DETAILED CONSERVATION COMMISSION AGENDA

Date: Thursday, November 18, 2021

1. (7:00) 5 Harwich Road – NOI – Addition to a single family home and deck – DEP #239-???

2 (7:30) 100 Boulder Road – NOI – tear down/rebuild single family home DEP file #239-???

**Riverfront Area
Mitigation
Planting Plan**

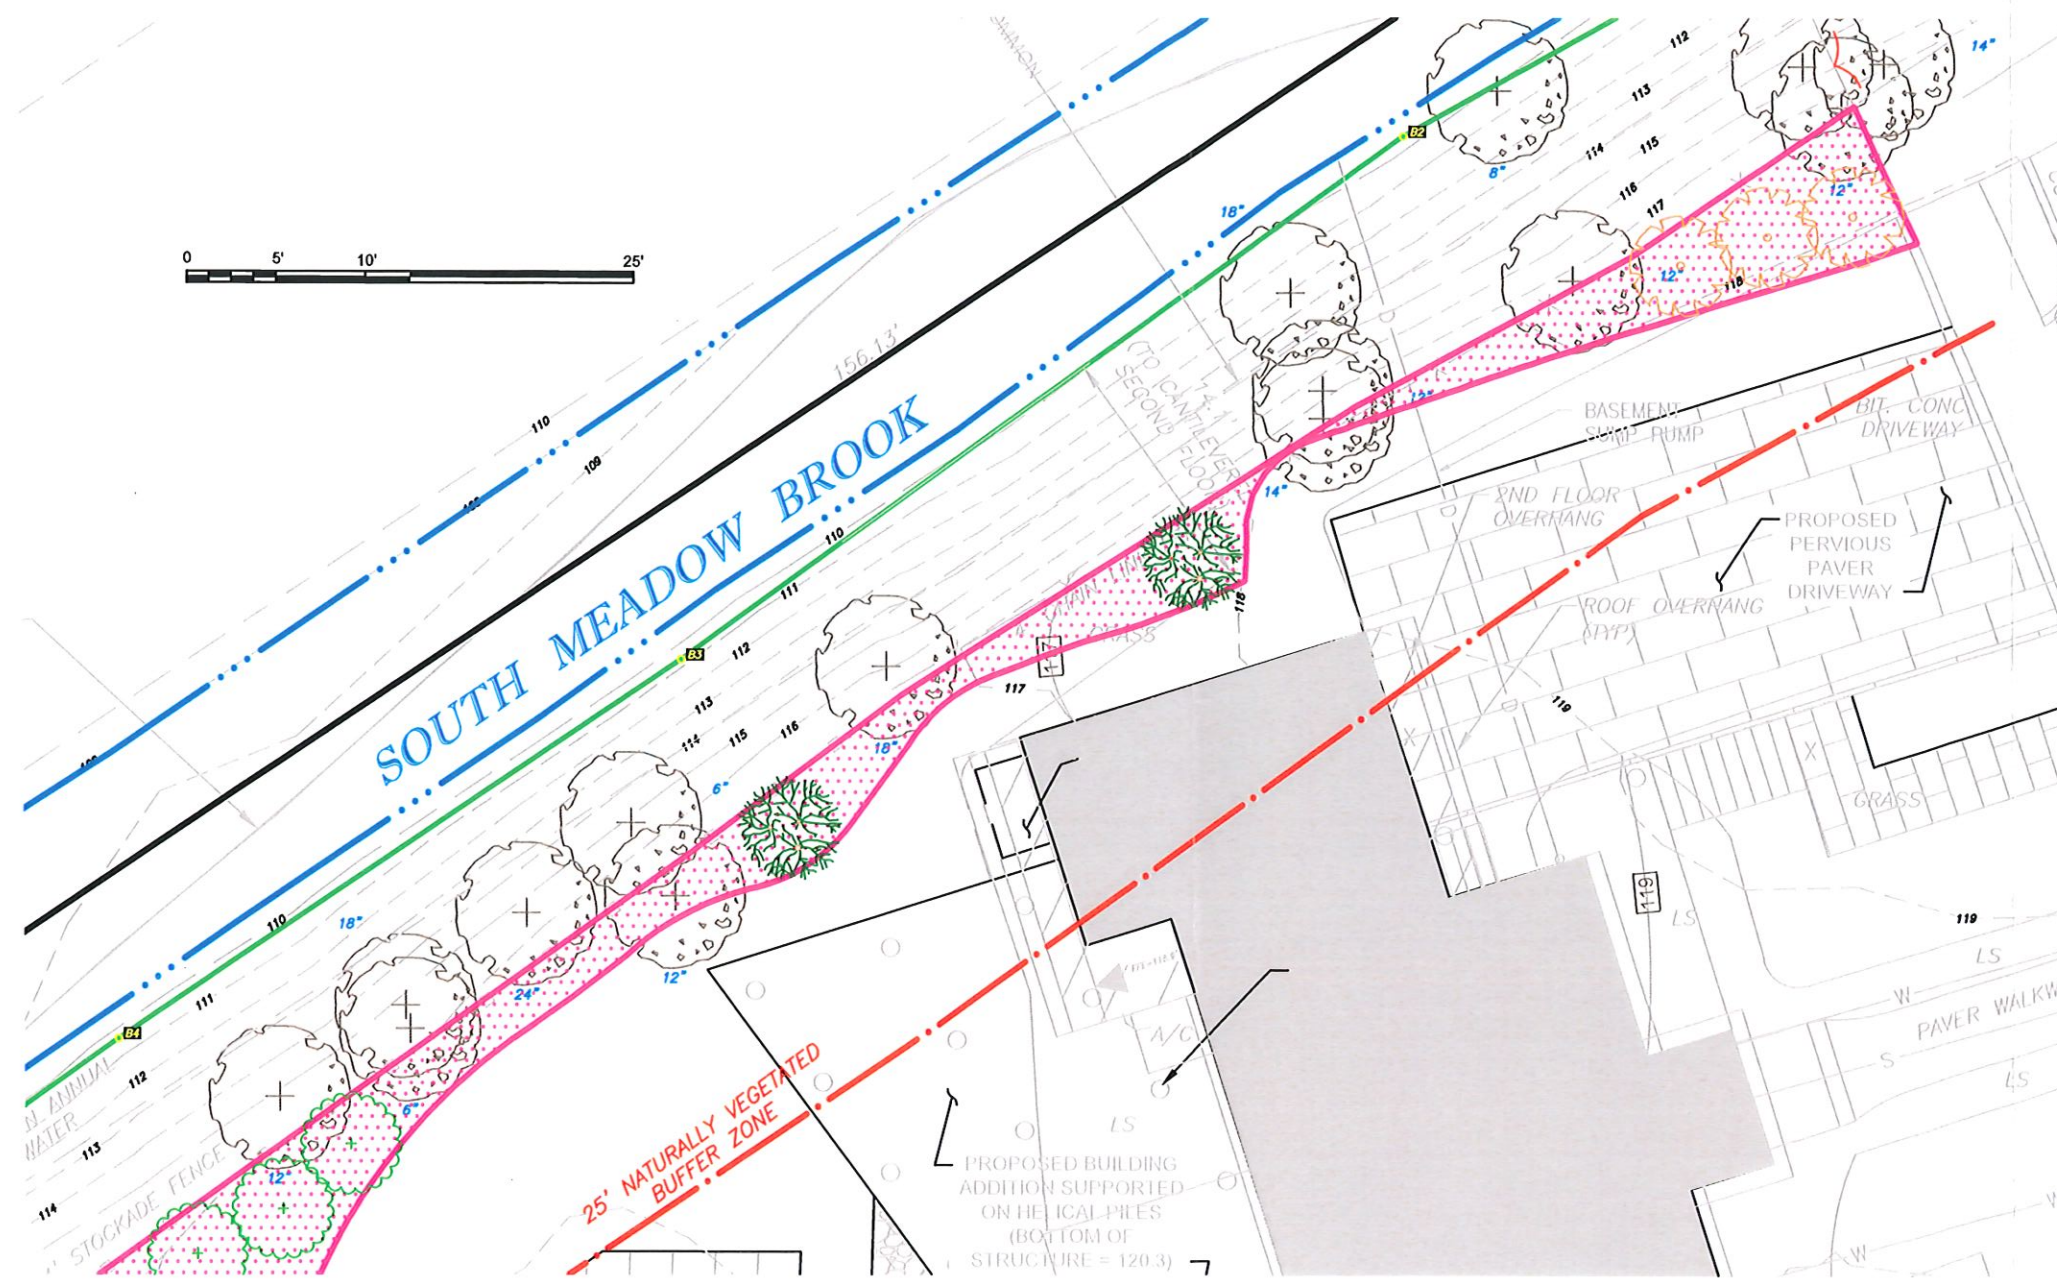
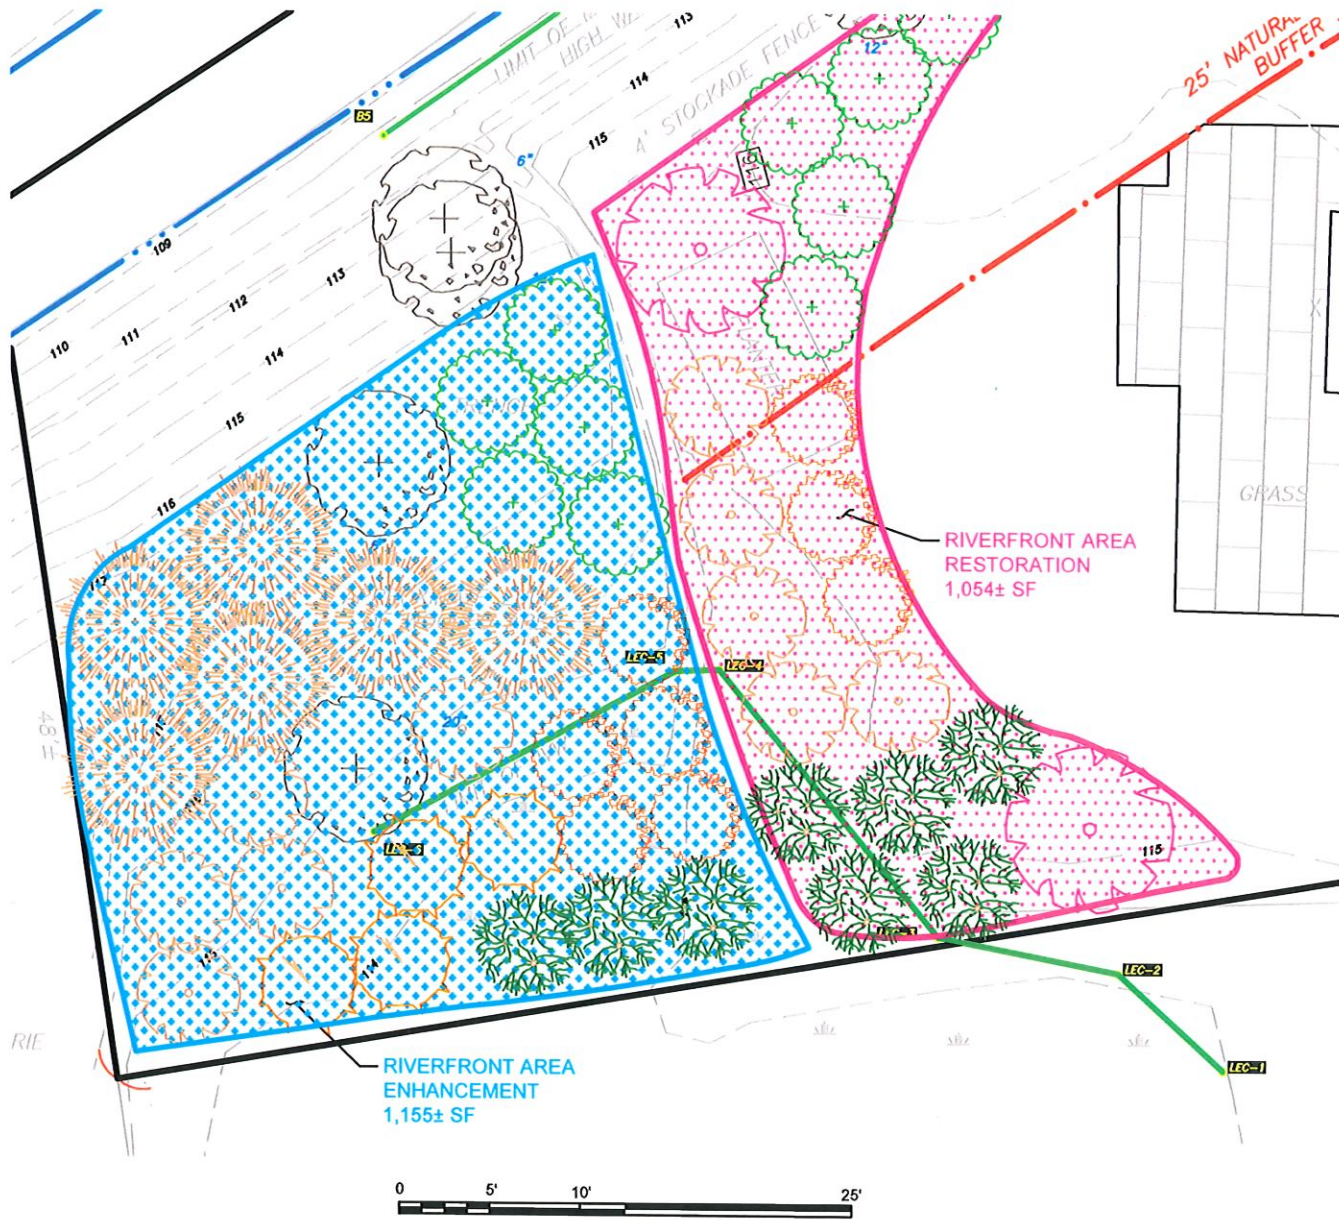
- Some of the “restoration area” is a narrow strip along the stream -- some of that strip was due to have been planted with native shrubs under a prior OOC, the very narrow and shady nature of the area will make true restoration challenging, and the narrowness of the strip runs counter to the Commission’s Mitigation/Restoration Planting Area Guidelines: “Narrow strips of planting areas have limited habitat value. Bed should be shaped to be as “consolidated” (i.e., non-linear) as possible.” The remainder of the “restoration area” is lawn with 3 large native landscape shrubs and saplings viburnum, cherry, and serviceberry.

- All of the “enhancement area” is currently densely vegetated with many native species. The plans imply that all existing shrubs and small trees will be removed and new plant stock installed. If that is true, staff question the logic of removing well-established native plantings.

- The planting schedule does not include any canopy trees.
- Staff note that there is no area identified for laydown or stockpiling on the plans.
- Engineering’s preliminary review noted:
